Access Compliance Report

Public Rights-of-Way

Intersection ID: 53777	Main Street: ROCK_ISLAND_RD	Cross Street: MOONLIGHT_BAY_WY	Location: S
ADA ID: C7A40FDF155D	Ramp Type: PerpDiag	Initial Pass/Fail: Fail	Overall Compliance: No
			Severity Score: 21.25

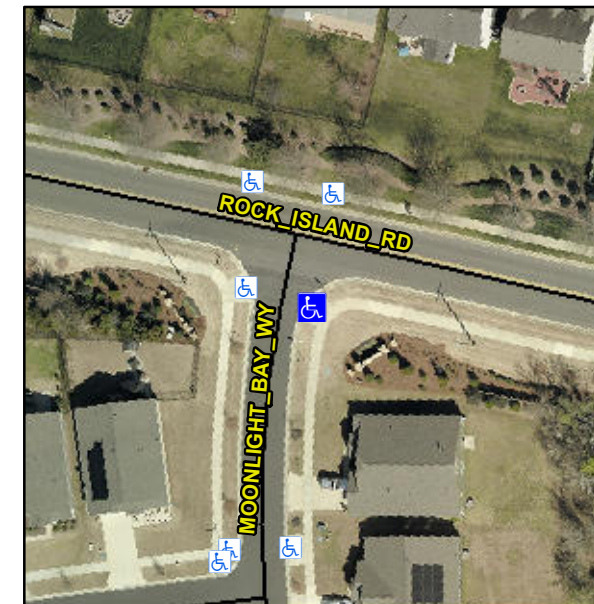
Remove & Replace Curb Ramp With Two New Directional Ramps or Equivalent.

R304.5.1, R304.5.3
